PDPLANPMTD-2025/054021

PROPOSAL: Dwelling

LOCATION: 16 Beachview Court, Lauderdale

General Residential Zone

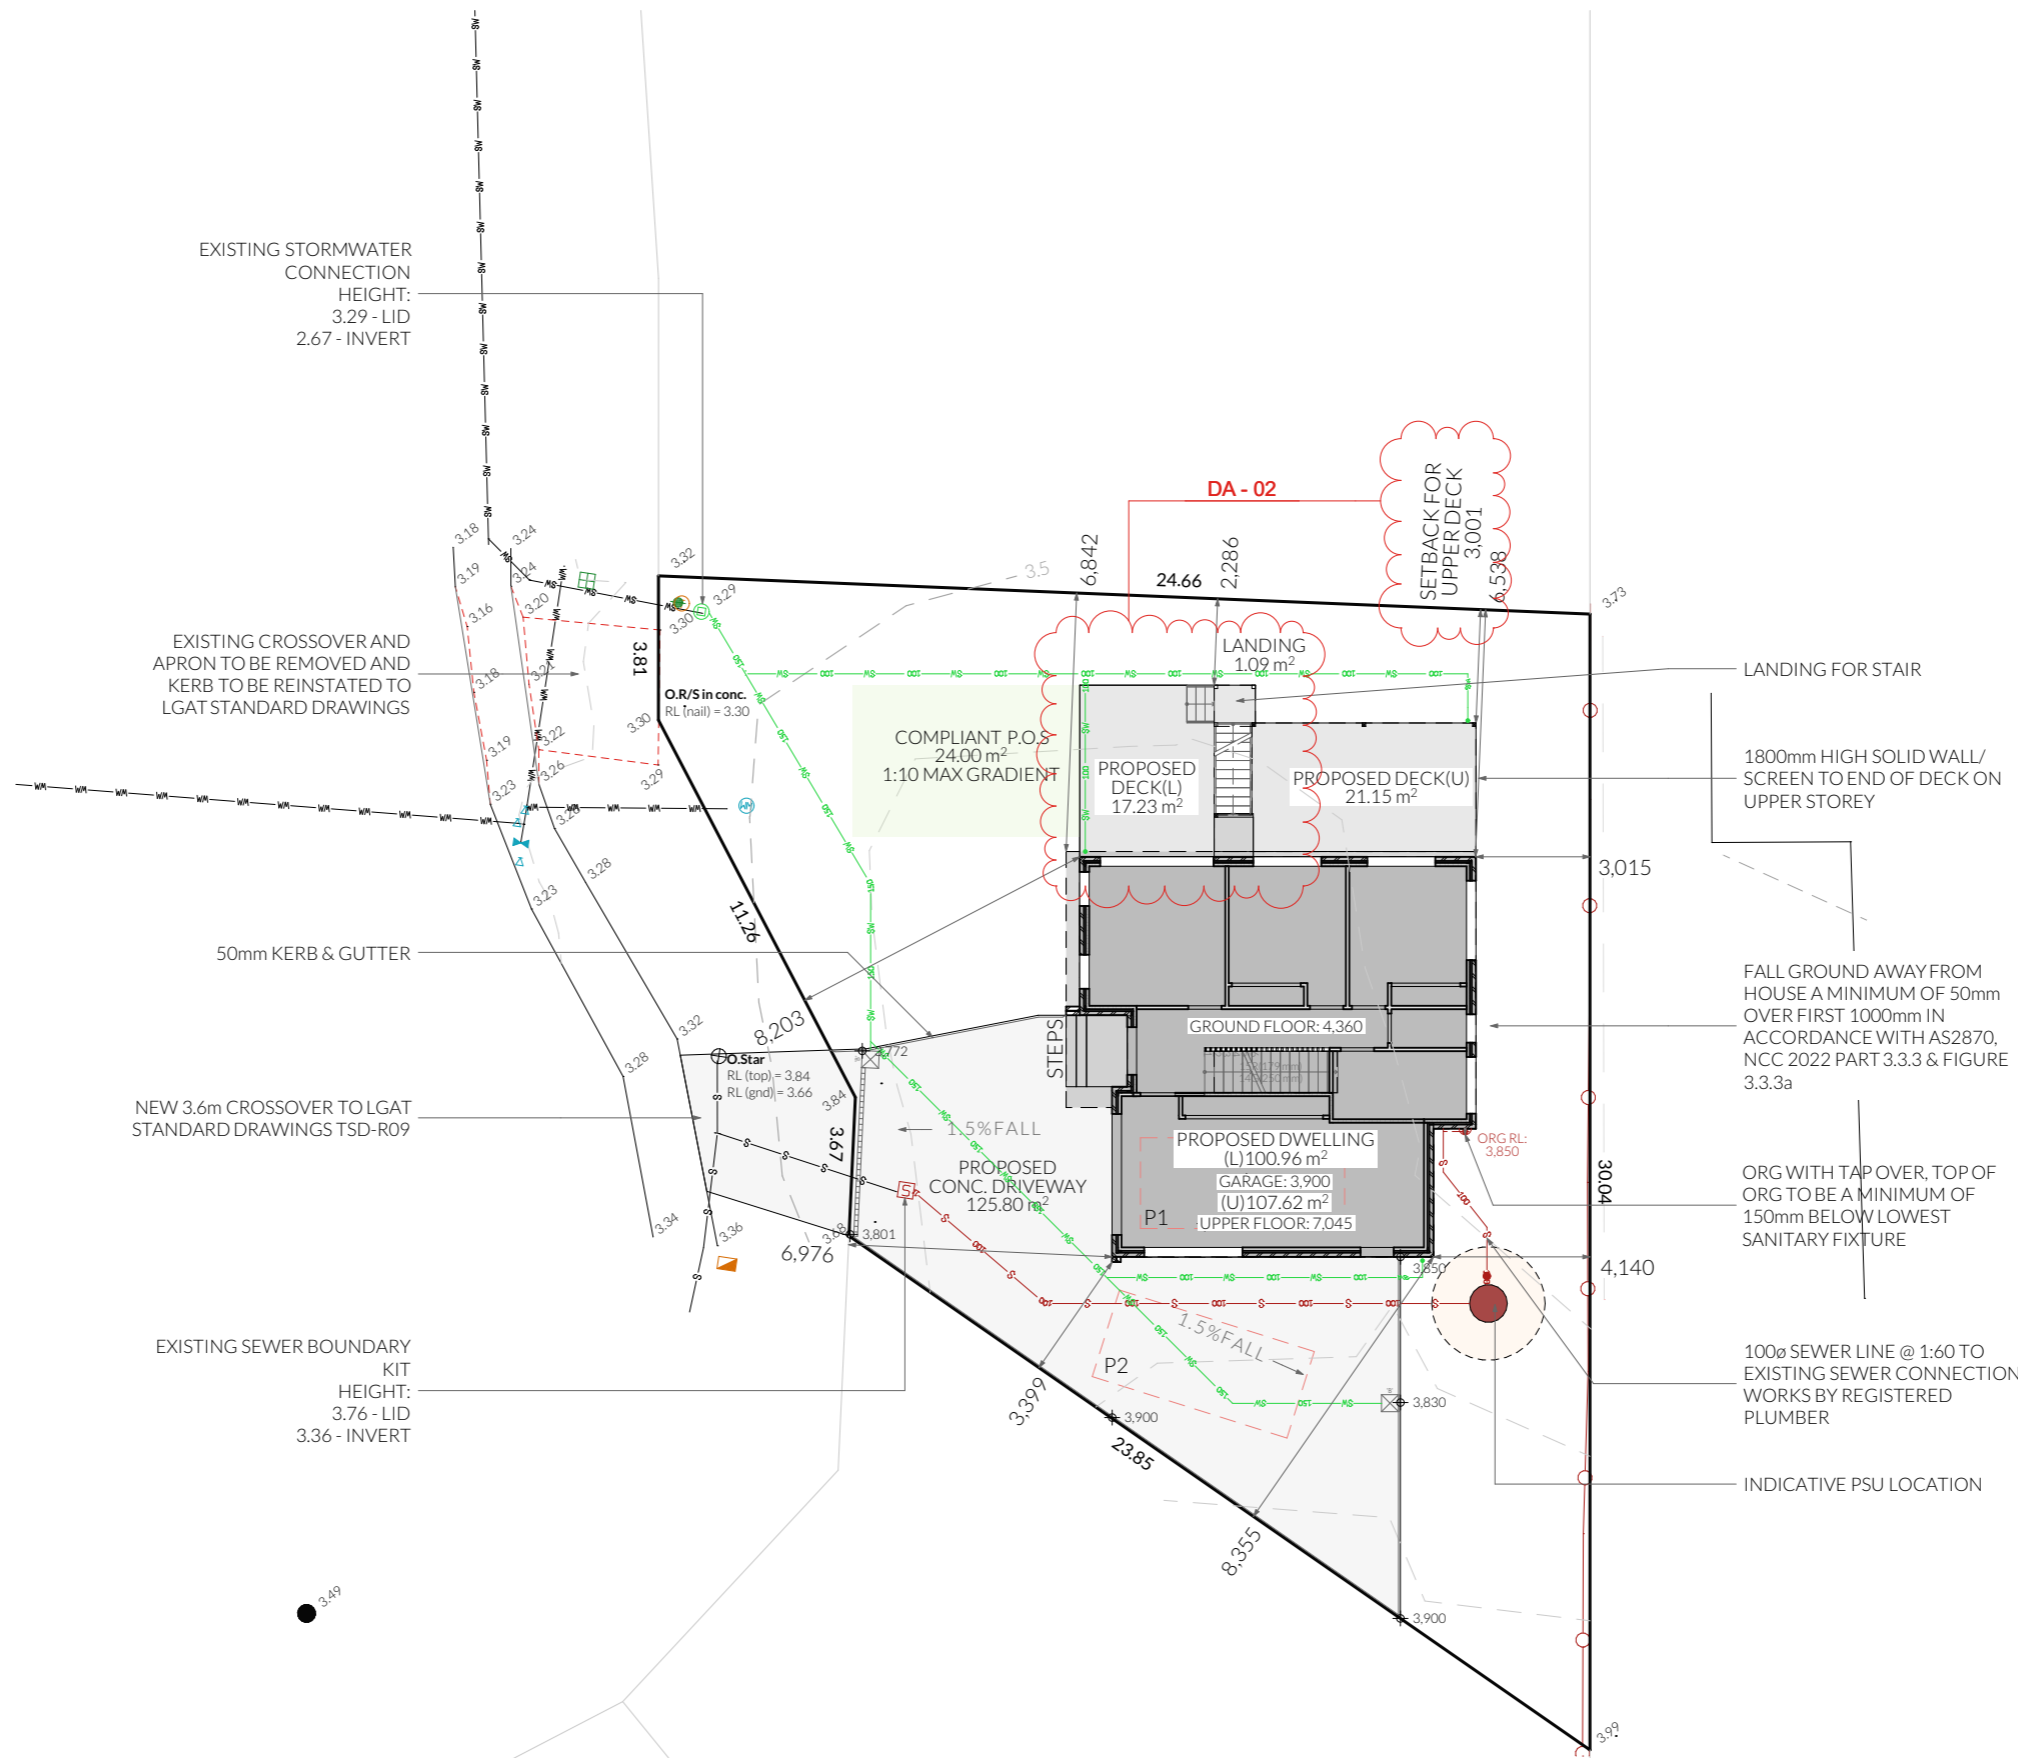
Please show two compliant car parking spaces to address the Acceptable Solution for Clause C2.5.1. Alternatively, please address the corresponding Performance Criteria.

Please show the driveway drainage to address the Acceptable Solution for Clause C2.6.1. Alternatively, please address the corresponding Performance Criteria.

Please show the driveway and parking gradients to address the Acceptable Solution for Clause C2.6.2. Alternatively, please address the corresponding Performance Criteria.

Refer to the amended site plan which clearly demonstrates two compliant car parking spaces.

The amended site plan now includes a stormwater design.

Refer to the updated site plan which includes spot levels and gradient annotations for both the driveway and car parking spaces.

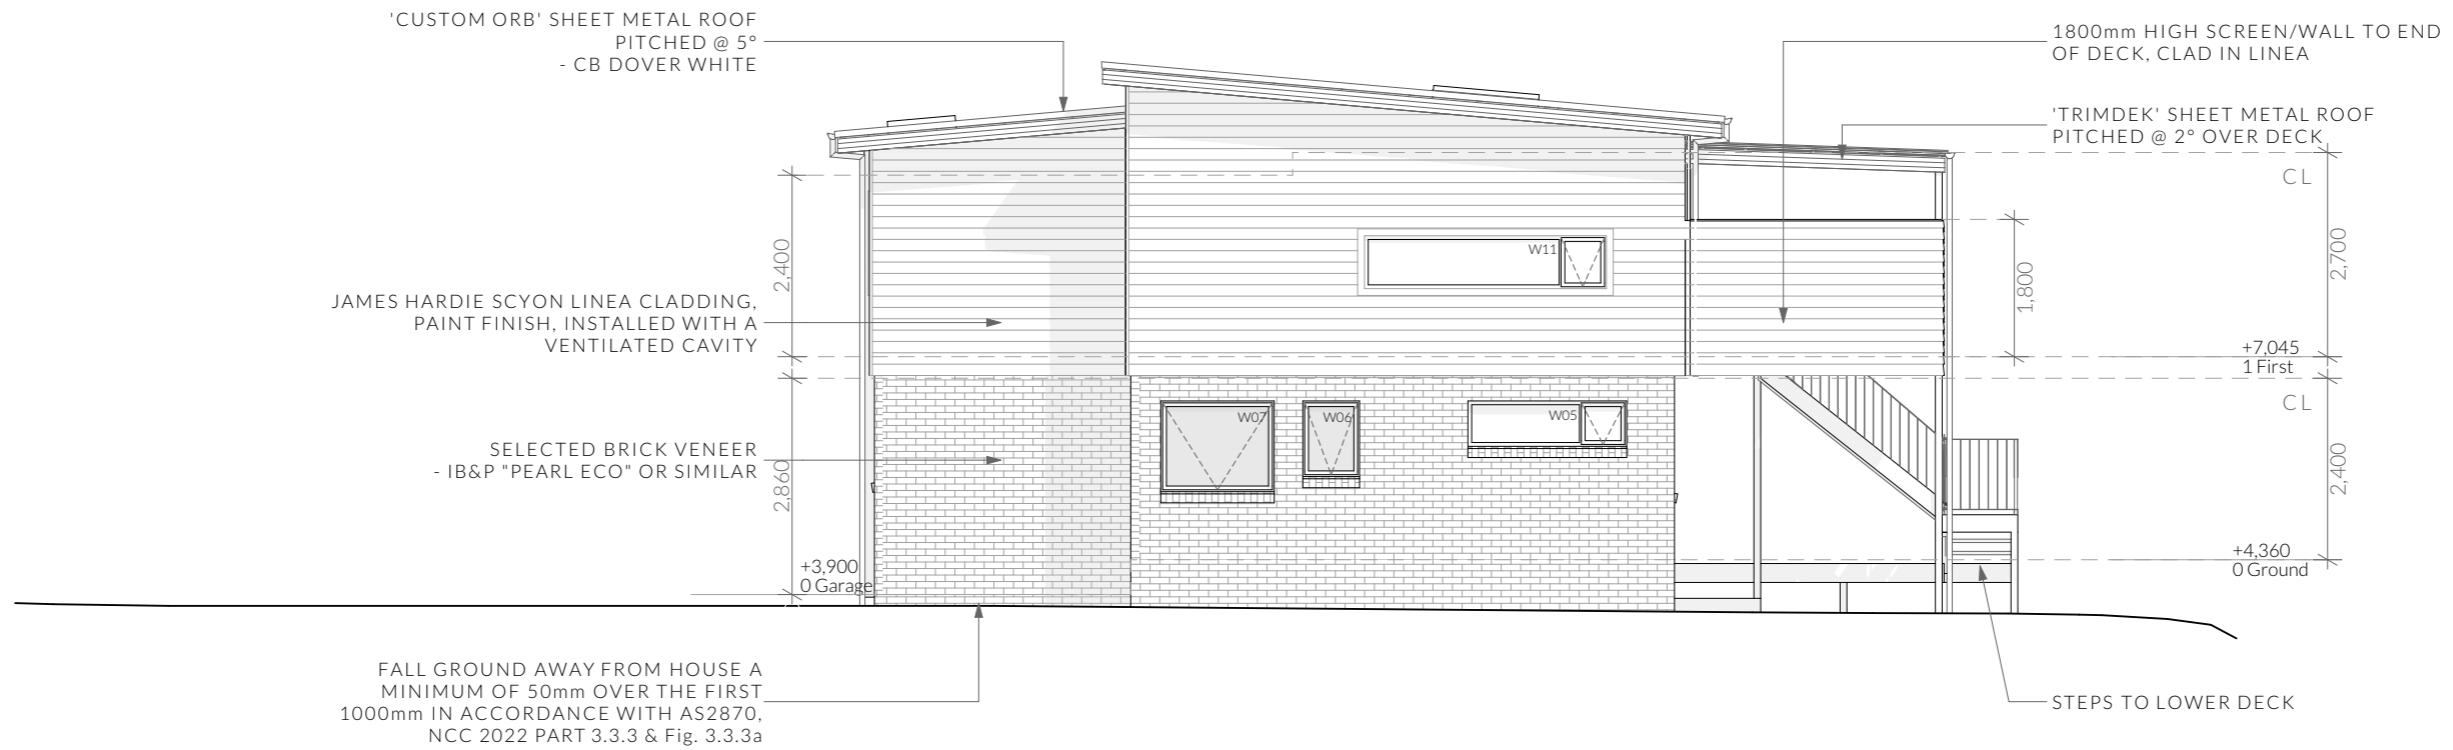
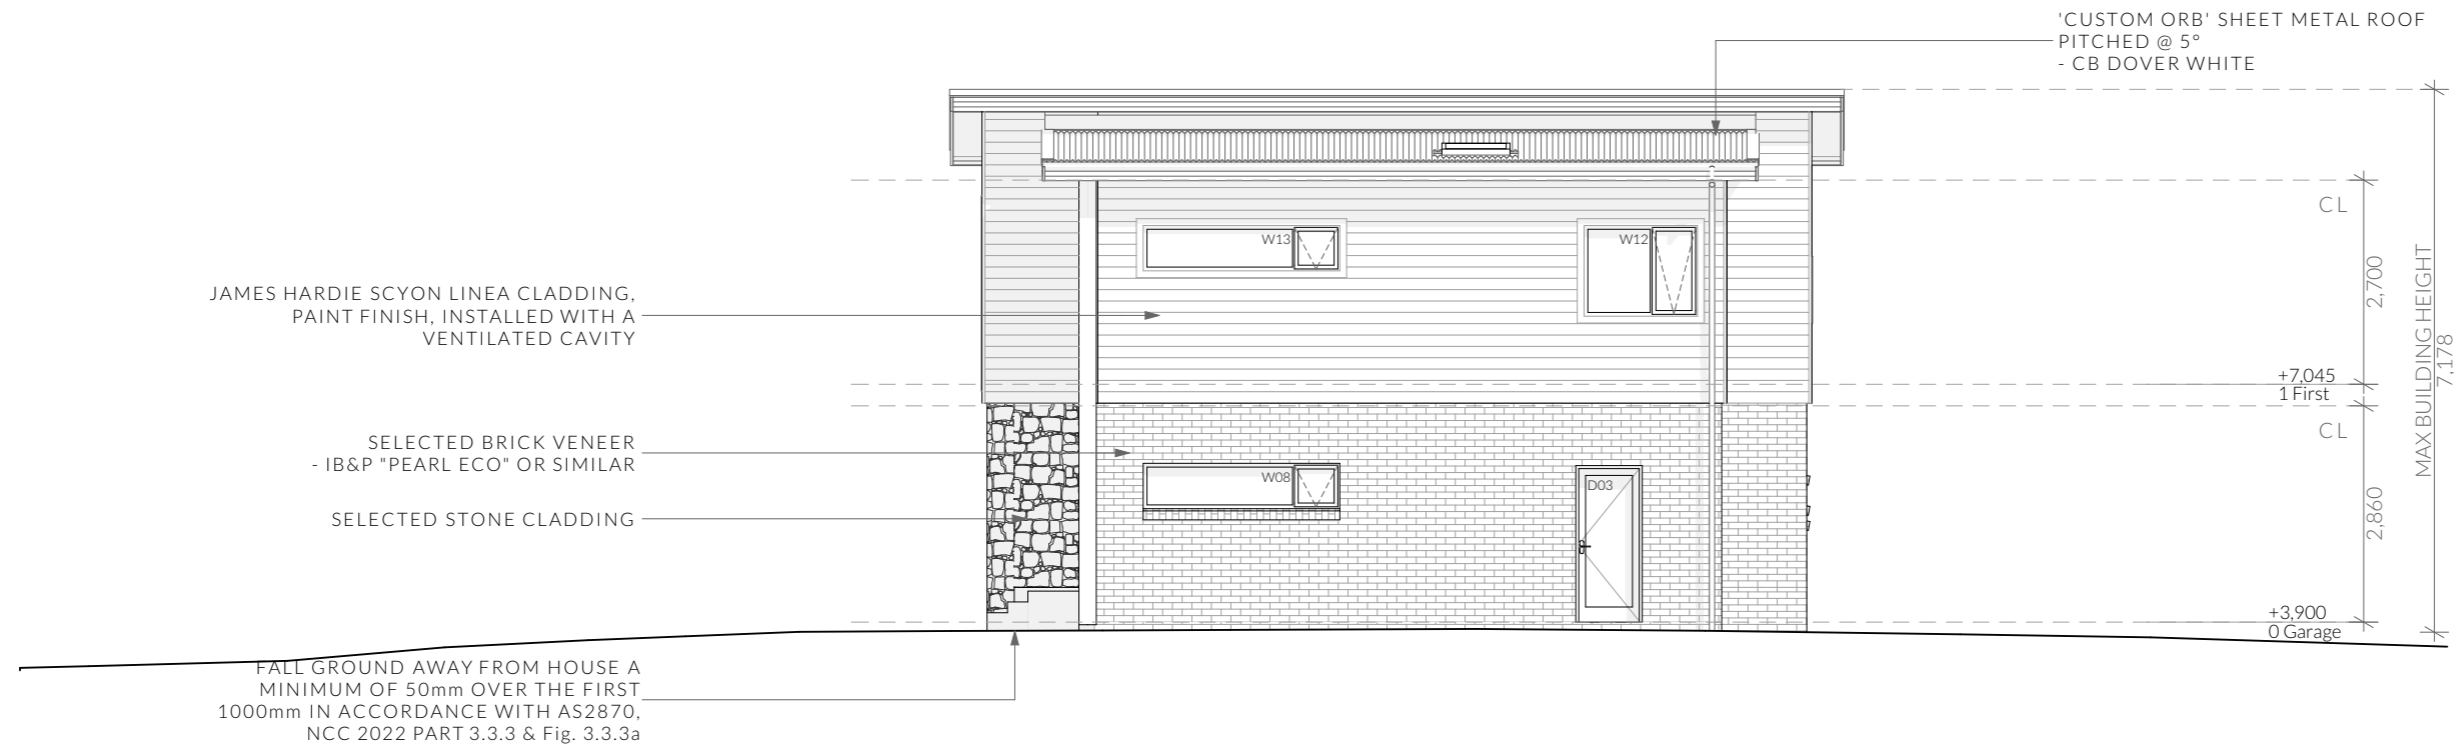
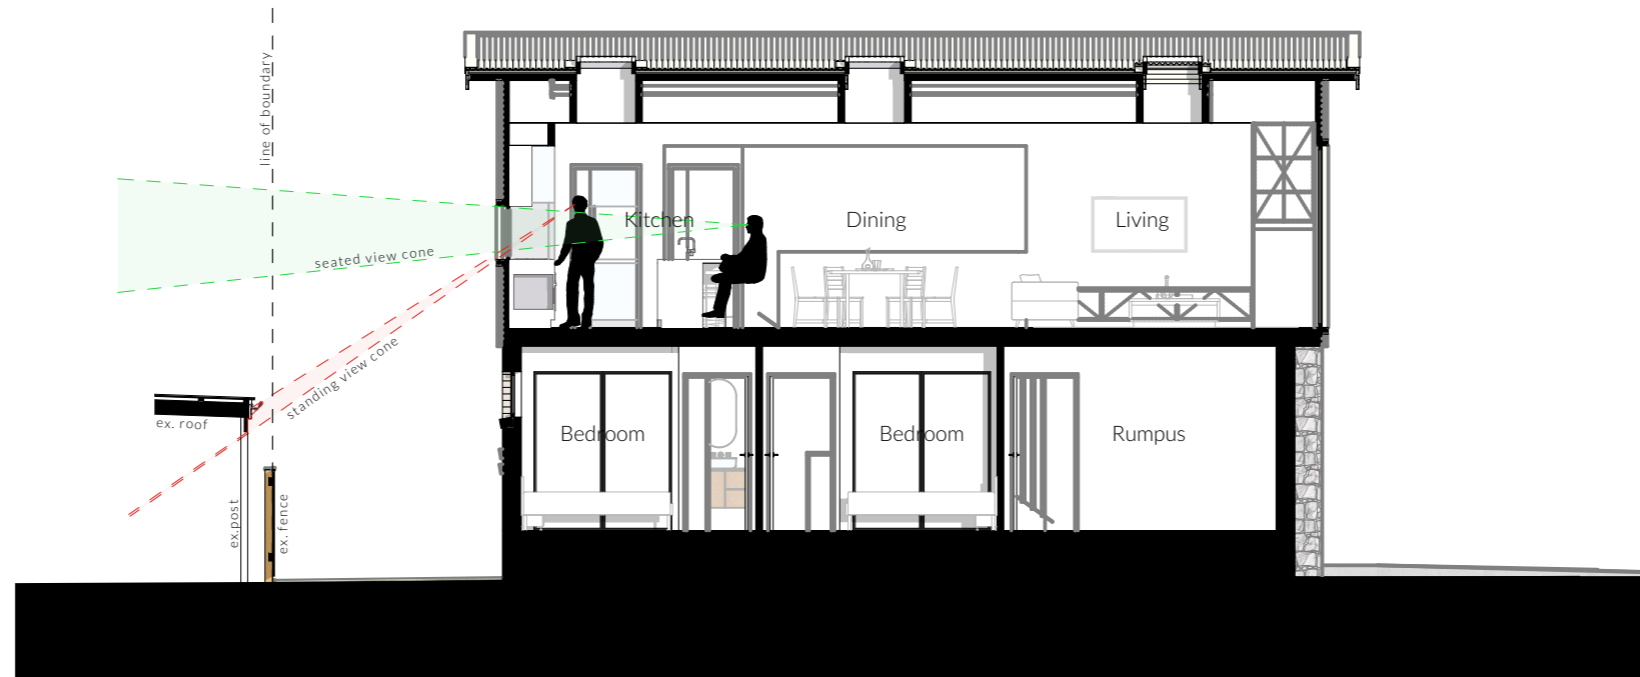
- *Please provide additional information showing how the deck satisfies the Acceptable Solution 8.4.6 A1(b) or address the corresponding Performance Criteria. Alternatively, please amend the deck to meet the Acceptable Solution by providing a permanently fixed screen to a height of not less than 1.7m above the finished surface or floor level, with a uniform transparency of not more than 25%.*

Refer to the amended elevations, which show the addition of a new 1800mm high solid wall on the eastern side of the upper-level deck in lieu of standard balustrade. This wall provides full visual screening, ensuring that there are no sightlines into the adjacent property and thereby protecting residential privacy as per the requirements.
